Docket Number:	17-AAER-07
Project Title:	General Service Lamps
TN #:	224605
Document Title:	Presentation - Industry Comments on CEC Draft Staff Report - Analysis of General Service Lamps (Expanded Scope)
Description:	By Joseph G. Howley - Comments on CEC Draft Staff Report 2018 GSL v2 for August 28, 2018, General Service Lamp (Expanded Scope)
Filer:	Patrick Saxton
Organization:	GE Lighting
Submitter Role:	Public
Submission Date:	8/27/2018 1:29:56 PM
Docketed Date:	8/27/2018

Industry Comments on CEC Draft Staff Report

Analysis of General Service Lamps (Expanded Scope)

2018 Appliance Efficiency Pre-Rulemaking
Docket Number 17-AAER-07

Figure 3-6, NEMA Index Report, does not represent Current A-line Sales in California

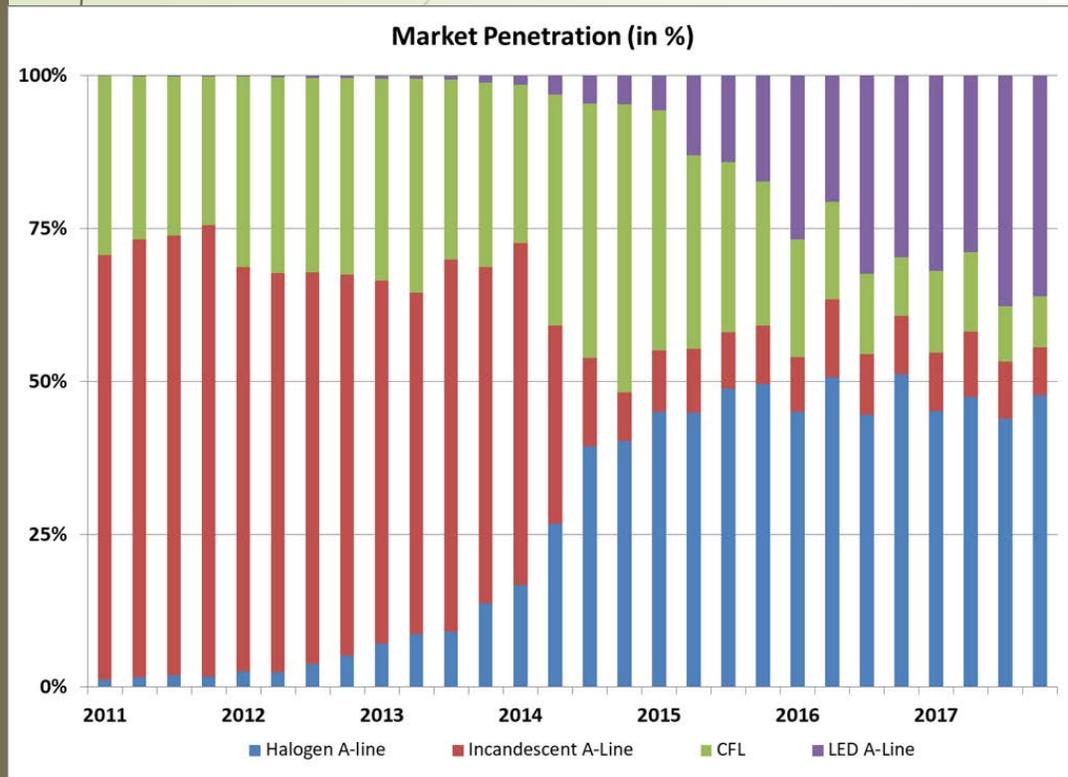
- Index report was designed to show the nationwide transition away from standard incandescent lamps since 2012-14 regulations by NEMA members.
- Index report not limited to regulated GSL: also shows low wattage incandescent lamps that are not regulated GSL.
- Index report only tracks reporting NEMA member sales.
- Because many LED lamps are sold by non-NEMA companies and fewer halogen/incandescent lamps are sold by non-NEMA companies, chart underestimates LED lamp penetration.
- Chart is under review by NEMA to provide more accurate indication of LED market penetration based on newly available LED data.
- The halogen lamps made in 2018, and represented by Blue in this chart, cannot be sold in California today.
